ADDENDUM NO. 1

February 5, 2019

This Addendum supplements and amends the original Plans and Specifications and shall be taken into account in preparing proposals and shall become a part of the contract documents.

**MUSOM
BOILER AND CHILLER
REPLACEMENT**

M1

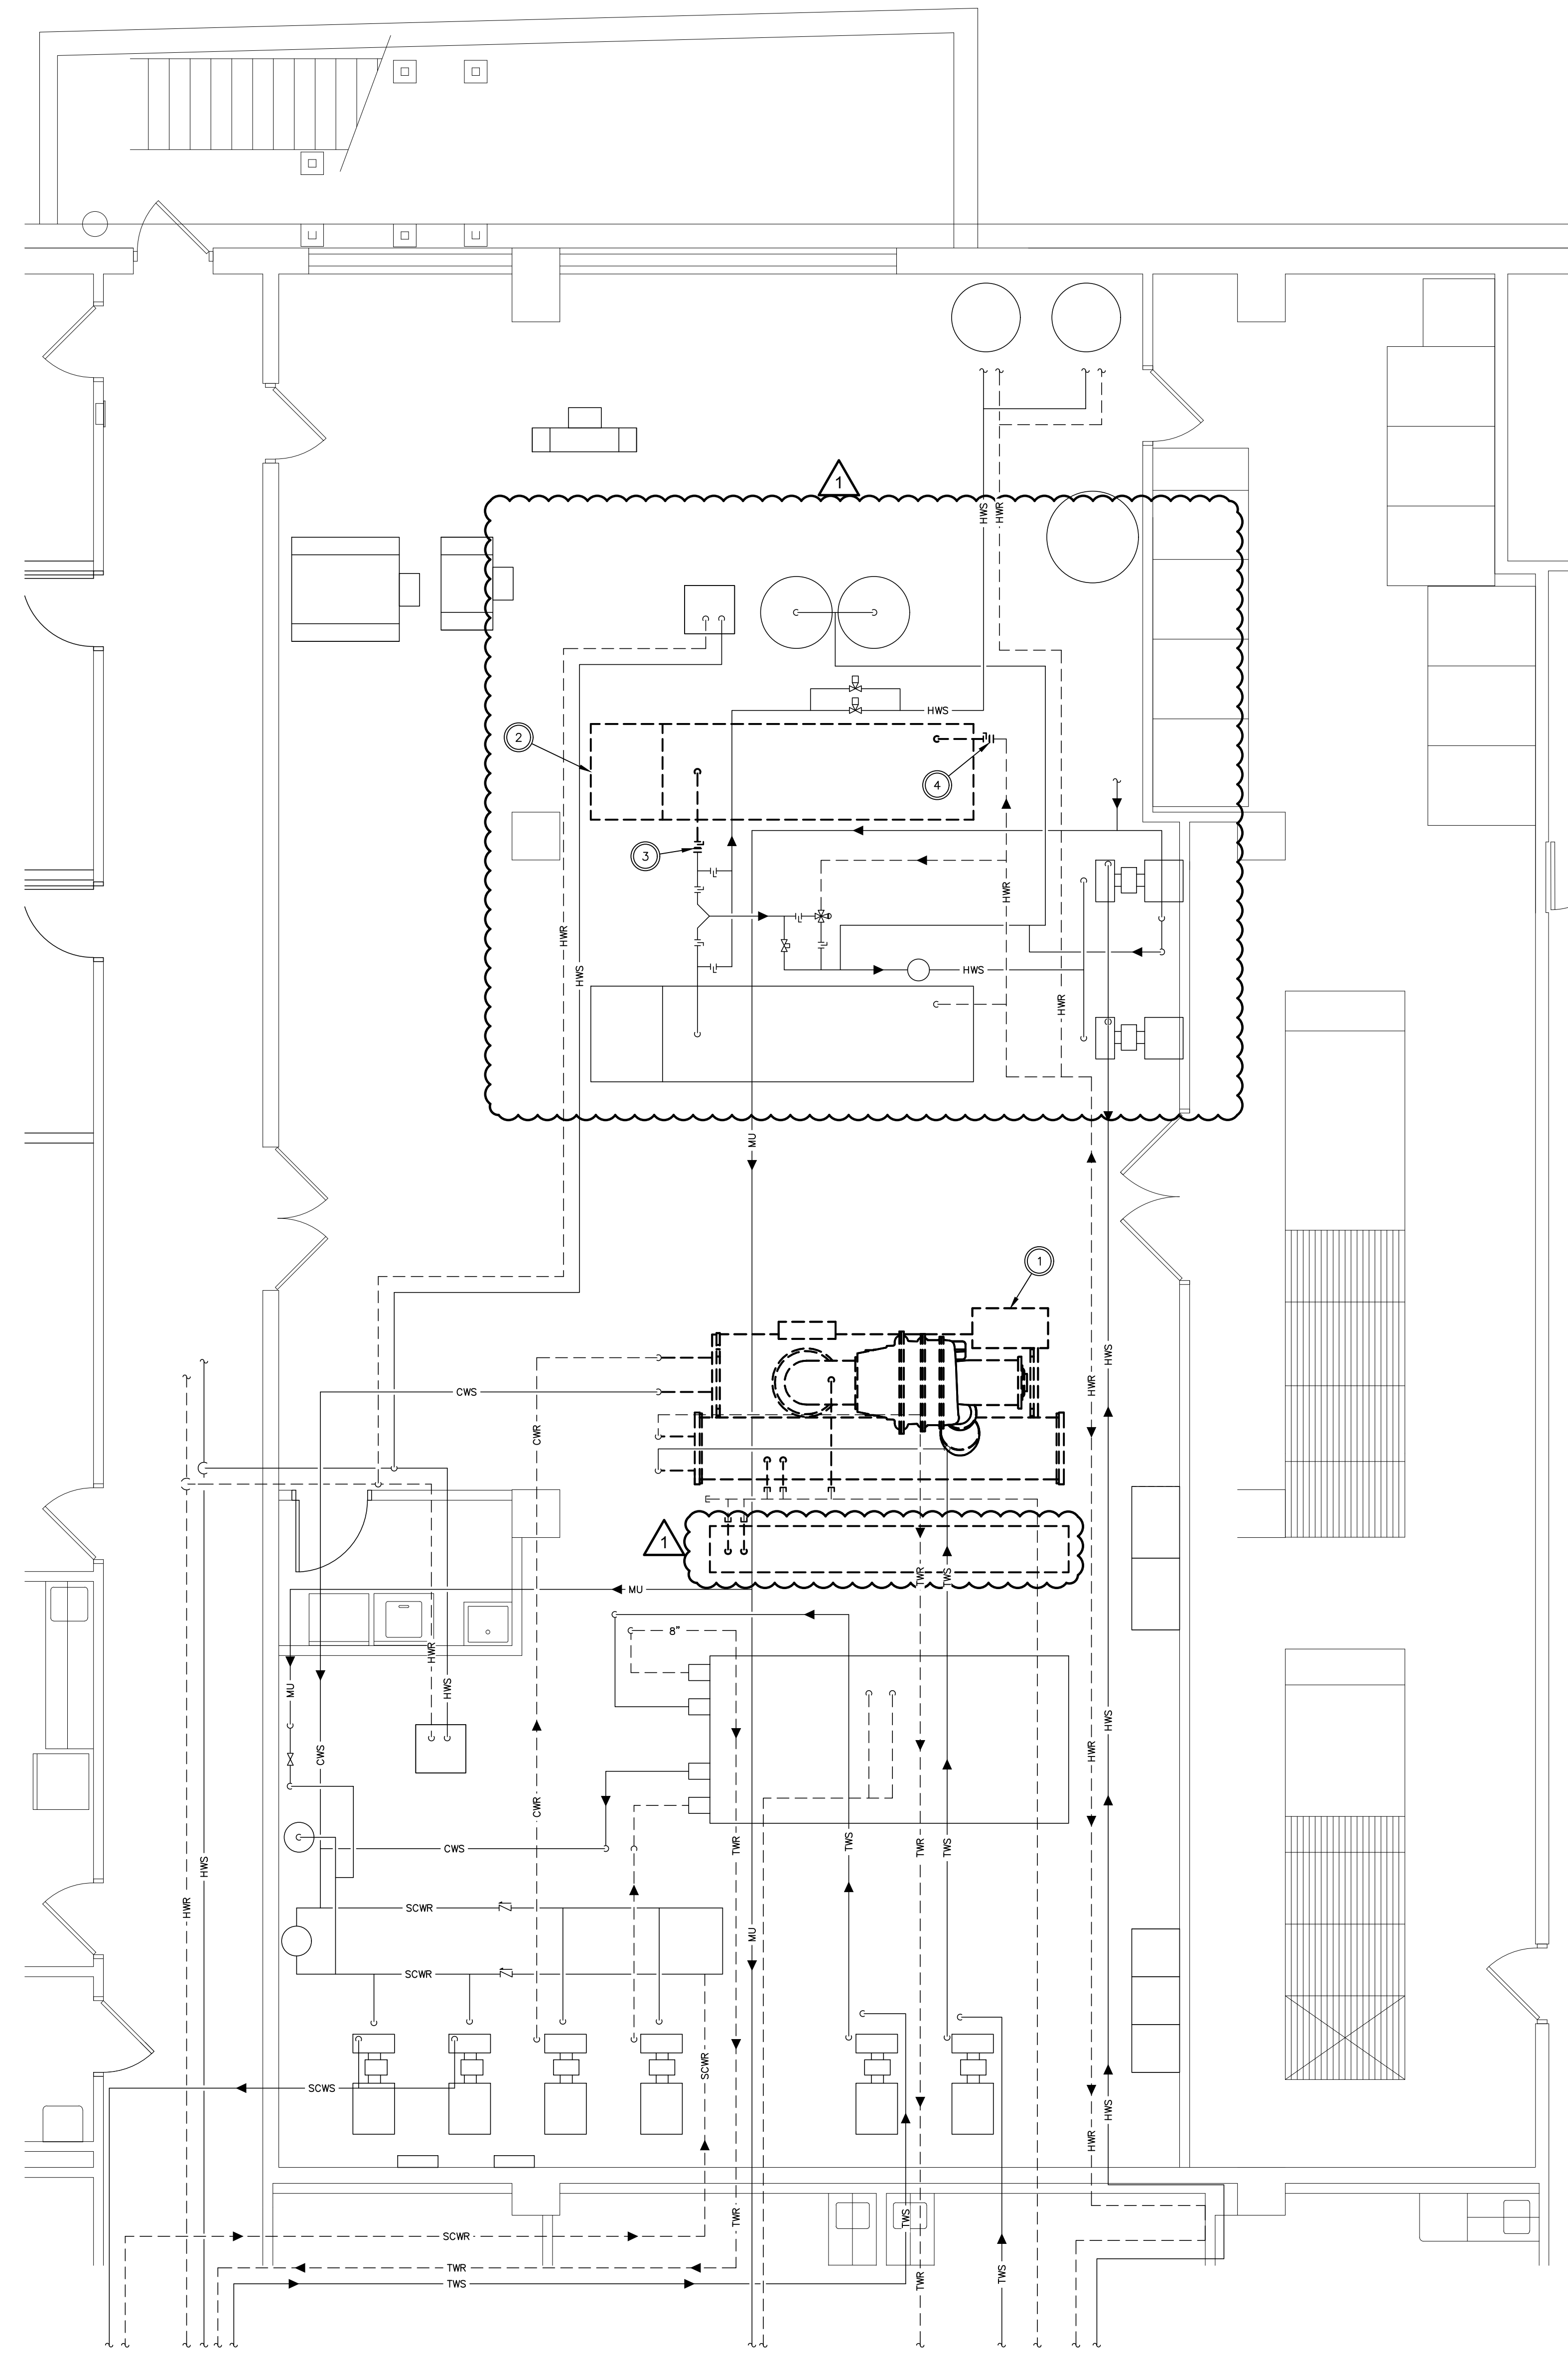
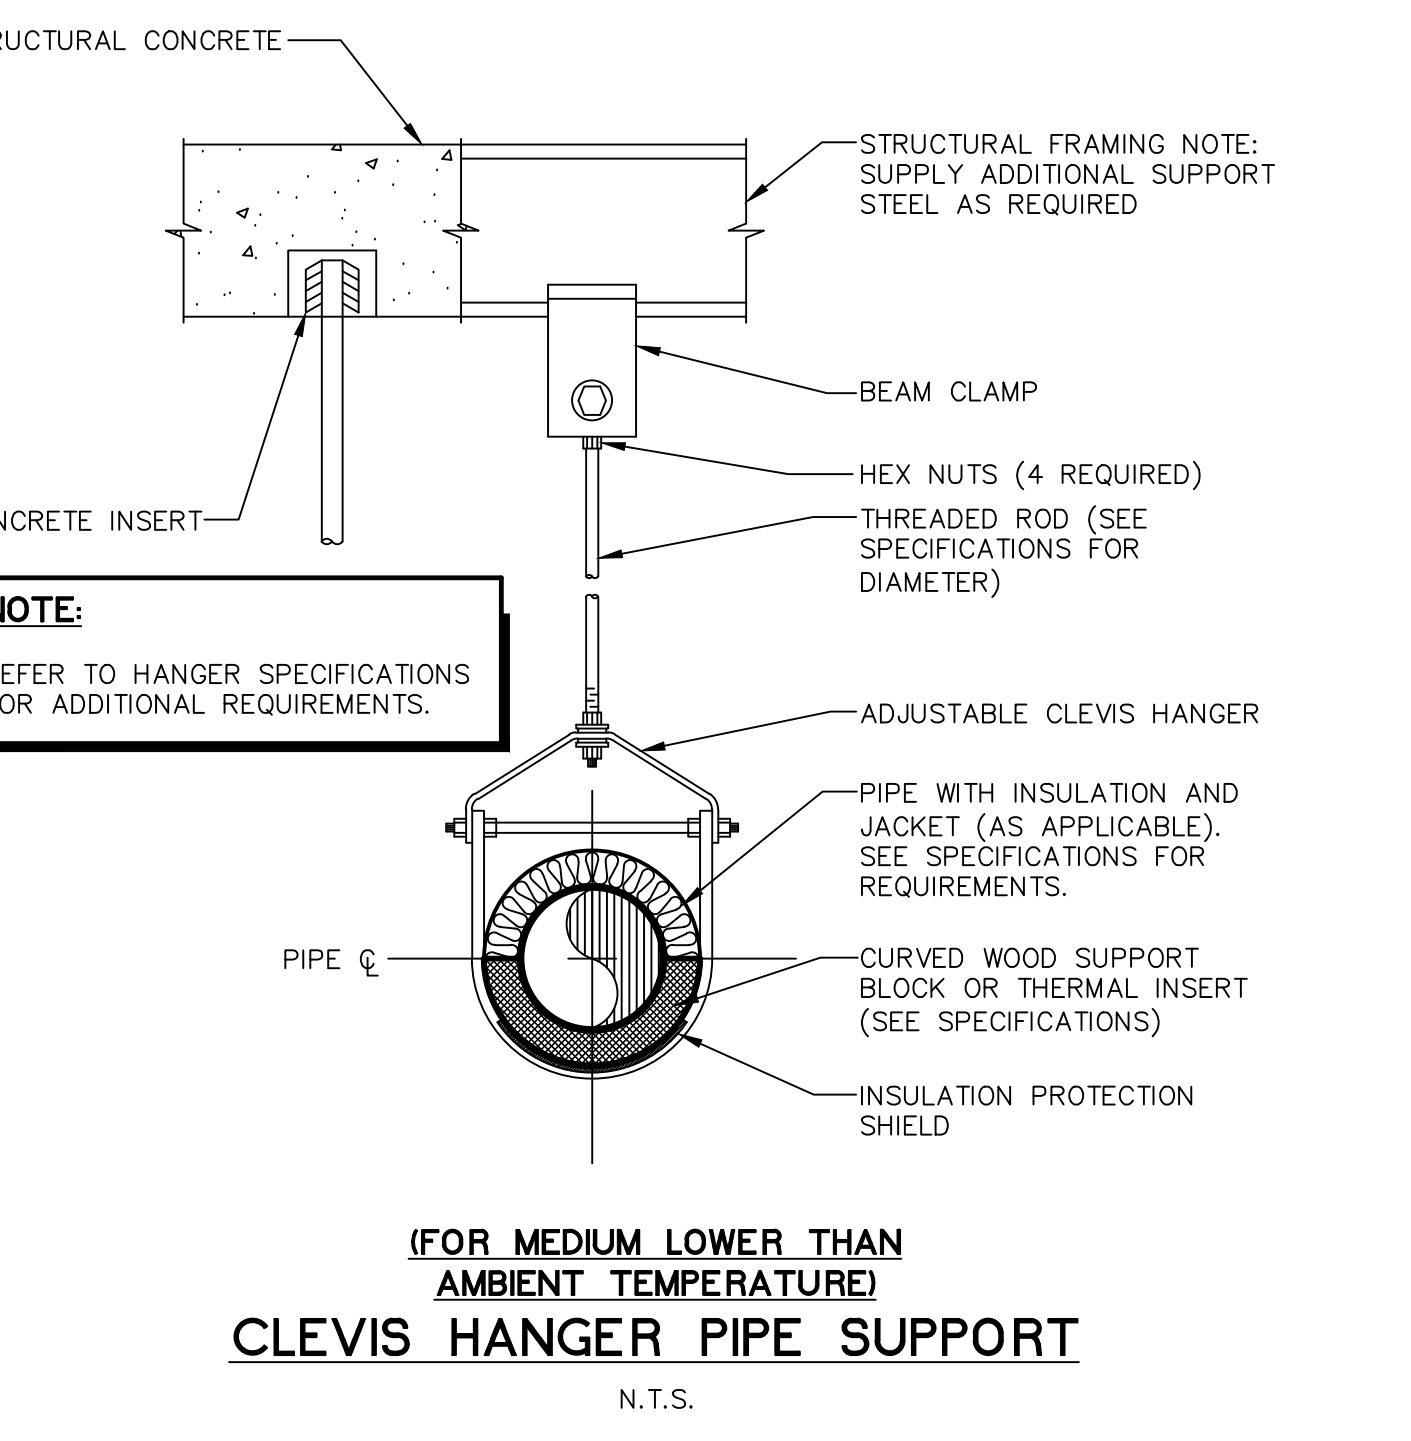
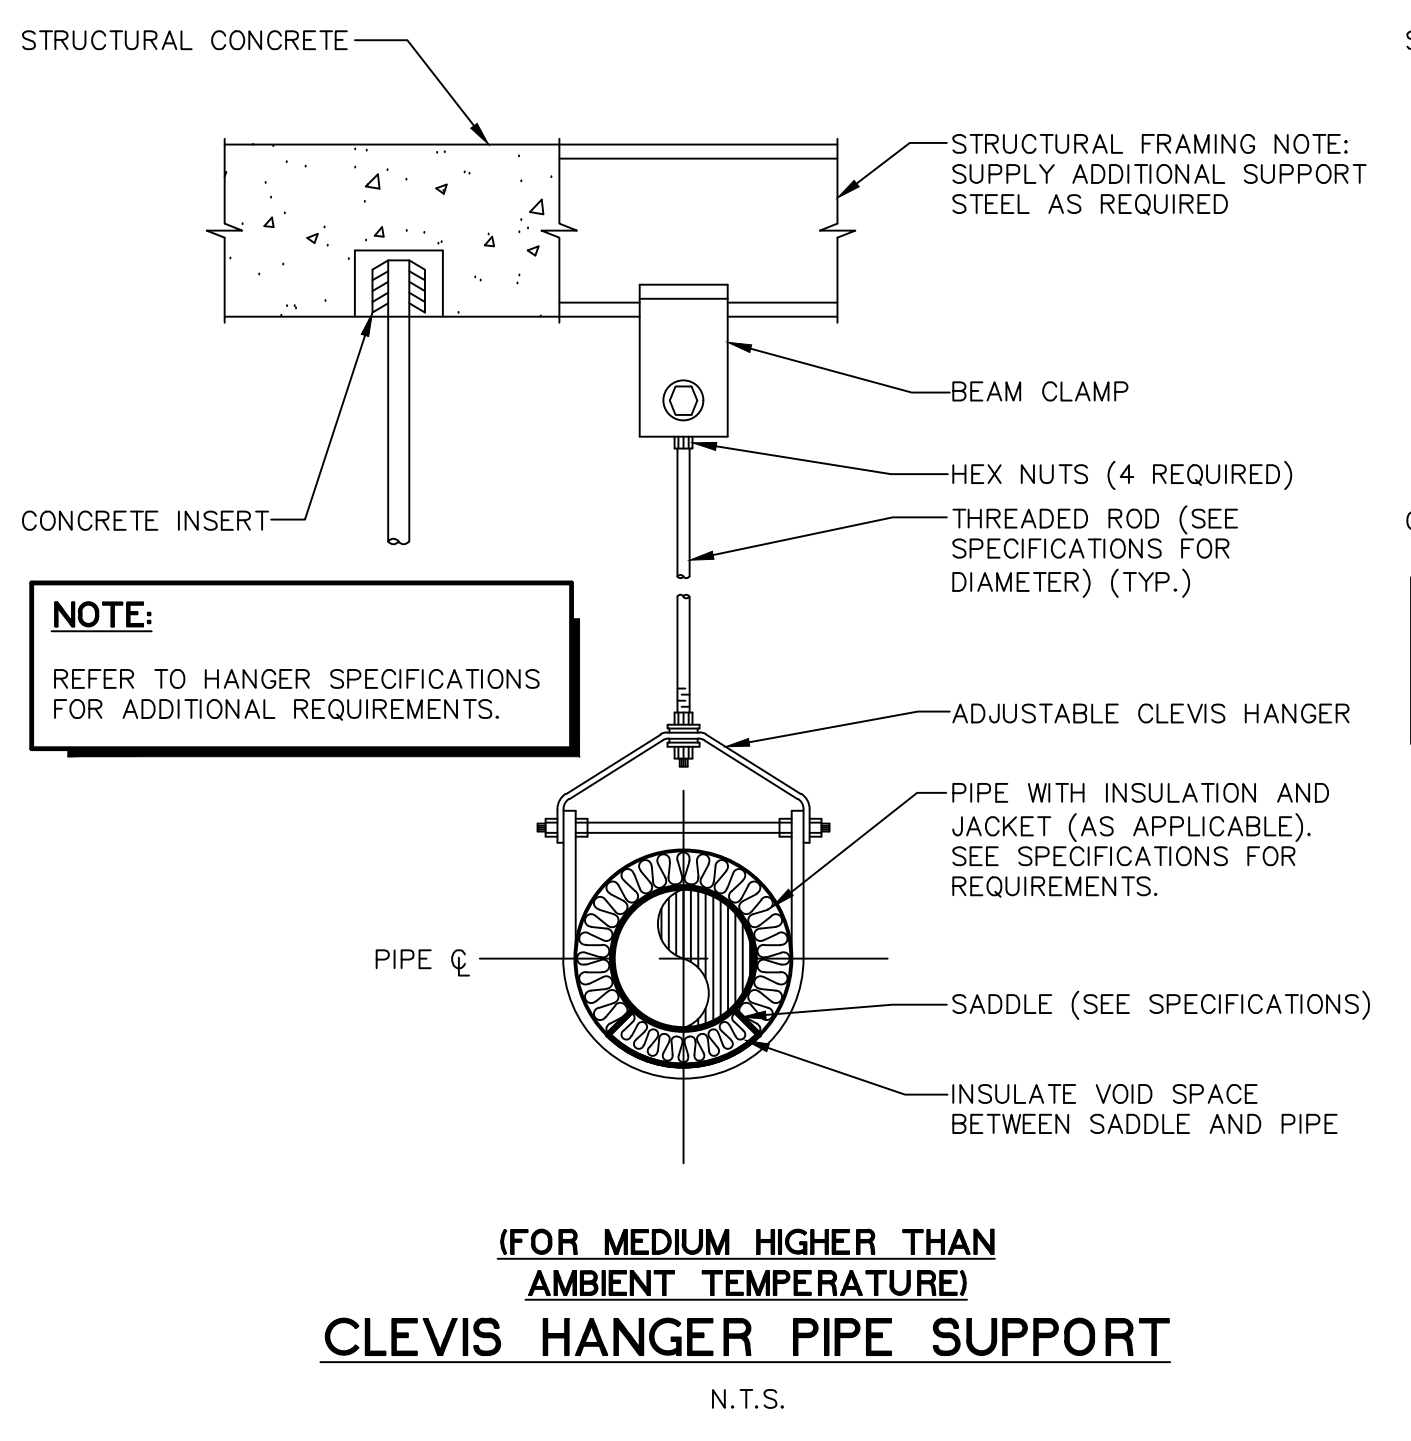
- These pads are to be removed.
- ITEM 10 Sheet M1, "General Notes, Symbol Legend, Details and Schedules"
- Refer to attached sheet M1 for removal of "In-Line Pump Installation Detail".

- Refer to attached sheet M1 for addition of "End Suction Water Pump Isometric".
 - Refer to attached sheet M1 for removal of "Hydronic Pump Schedule".

- Refer to attached sheet M1 for removal of "Buffer Tank Schedule".
- ITEM 11 Sheet MD1, "Demolition – Floor Plan – HVAC (Piping)";
- Refer to attached sheet MD1 for modifications to removal of heating water piping.
